PC 03-09-2026

Item #2

Update to the
Health and Safety
Element of the
Cupertino General
Plan: 2015 -
2040 Community
Vision

High-Risk Zones Require Street-Level Modeling

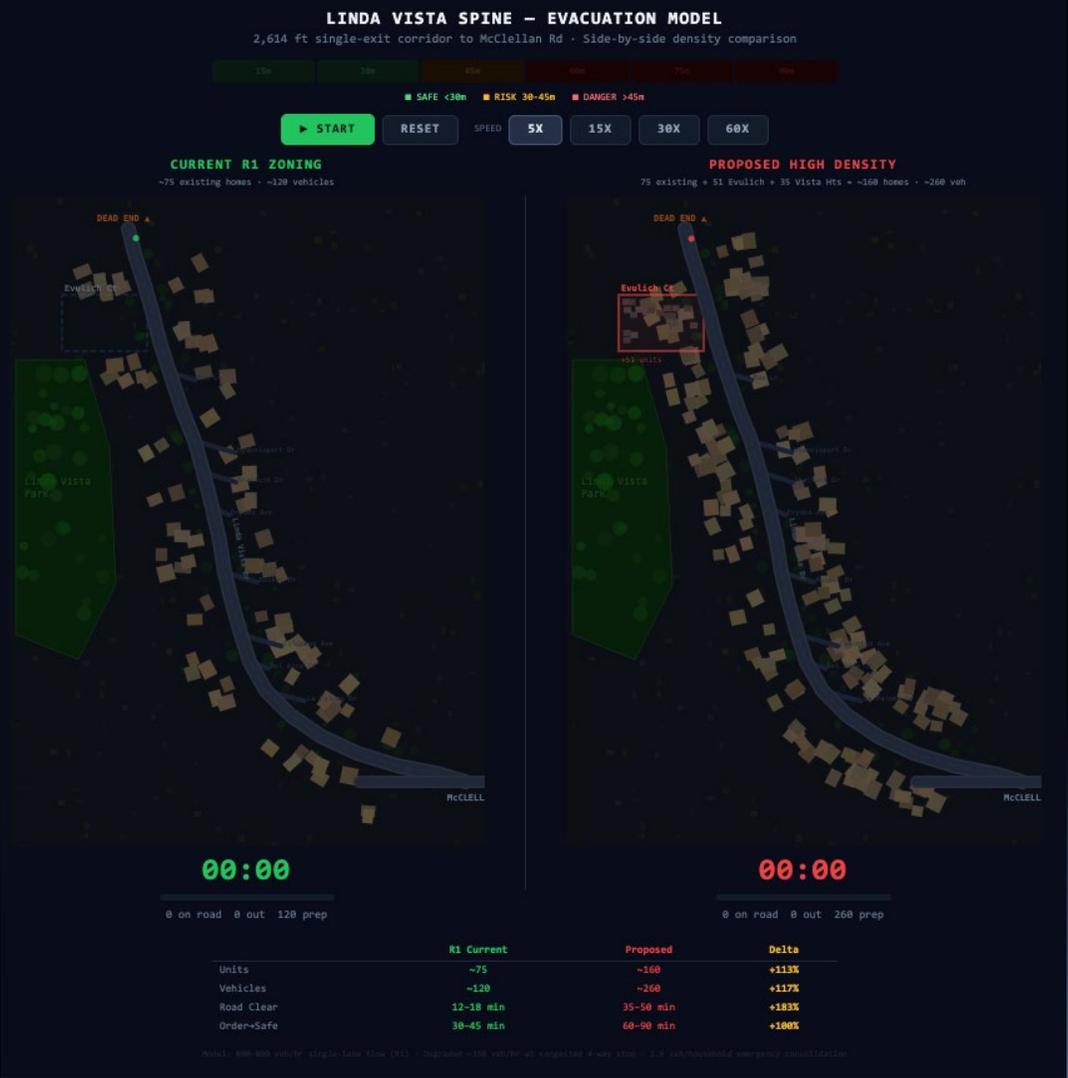
Four evacuation zones lie within Fire Hazard Severity Zones, yet the City has not modeled their street-level evacuation behavior.

- All designated evacuation routes lie outside FHSZ
- But CUP016, CUP017, CUP029, CUP032 lie inside Moderate–Very High FHSZ
 - CUP029 alone = 38% of all evacuation trips
 - McClellan Road V/C = 4.2; Foothill Blvd V/C = 4.0
 - These are not “constraints” —they are system failures
- City must adopt:
 - Street-level DTA, Real-time traffic management, Phased evacuation strategies for FHSZ zone

Thousands of residents remain exposed until Cupertino models evacuation where the risk actually exists.

Evulich Ct. : Evacuation to Safety Modeling

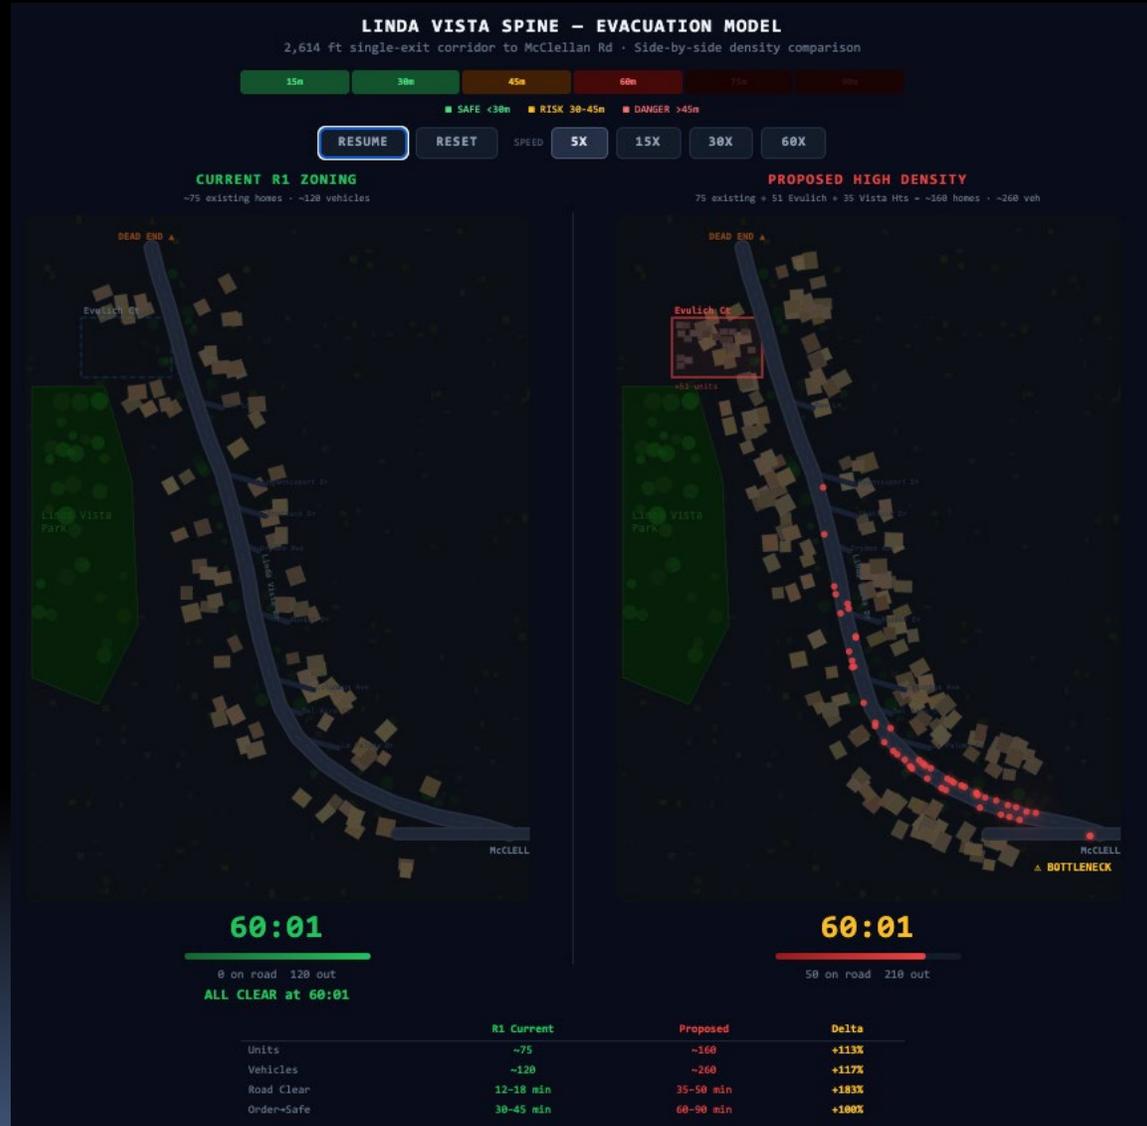
5' after Red Flag Warning issued

15' after Red Flag Warning issued

30' after Red Flag Warning issued

45' after Red Flag Warning issued

60' after Red Flag Warning issued
